<b>Product End Of Life Notification</b>		Date January 22, 2018
<b>Product</b>	Consolidation: Digi One SP Notice # 180122-02

<b>Description of change</b>	<p>The Digi One SP products have traditionally had a part number for North America (domestic) and a part number for International (rest of world) with the only difference being the power supply accessory. As part of the effort to streamline our product offers, we are consolidating the pairs of part numbers into <u>one Worldwide part number</u>. Certifications are identical on each of the part number pairs.</p> <ul style="list-style-type: none"> <li>As of February 5, 2018, the replacement (worldwide) part number* will be updated with a different power supply that allows for exchanging of the power plug. The power supply will ship with a US power plug on the power supply and a separate box containing EU, UK and AUST plugs.</li> <li>The current International part number will continue to ship as is until the last time buy ship date, which is noted below.</li> </ul> <p>This is an ongoing effort to streamline and consolidate our product offerings to focus on consistent product availability while maintaining our high quality.</p> <p>All

24000056

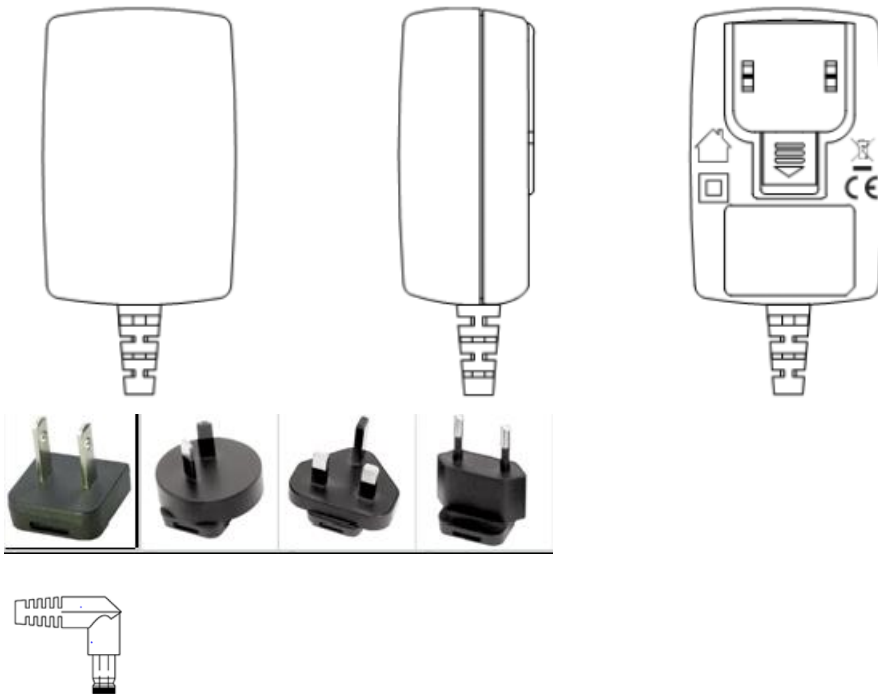
US power plug is default w/ interchangeable power plugs: EU, UK and AUST

Dimensions: Size: 74.0 x 43.5 x 34.0 +/-1.0 mm. Right Angle connector.

24000052

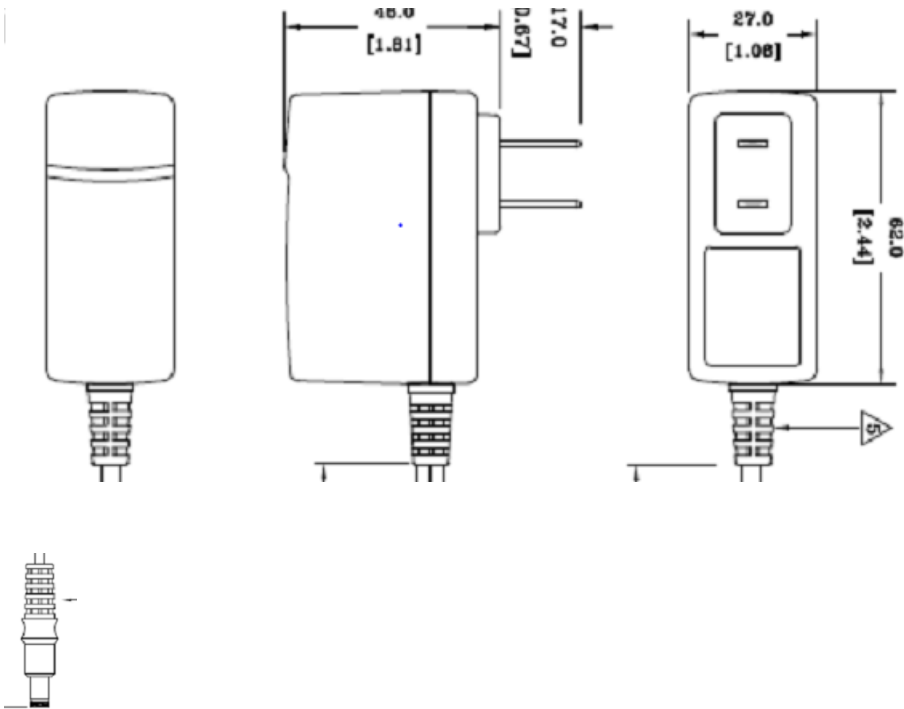
US power plug only. Straight connector vs. 24000091 has right angle.

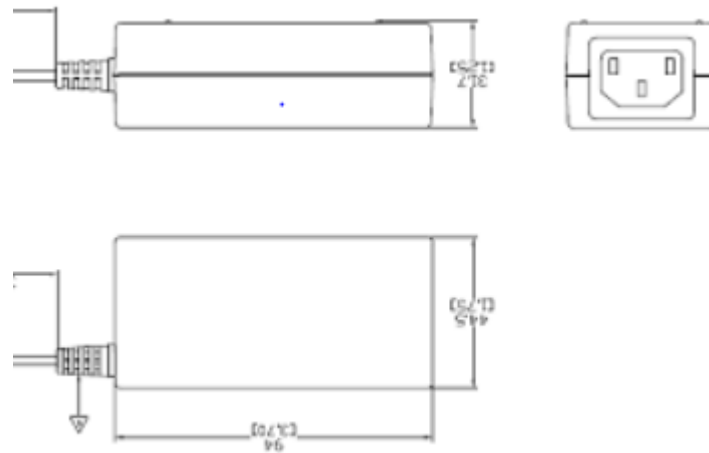
24000028. Straight connector vs right angle.
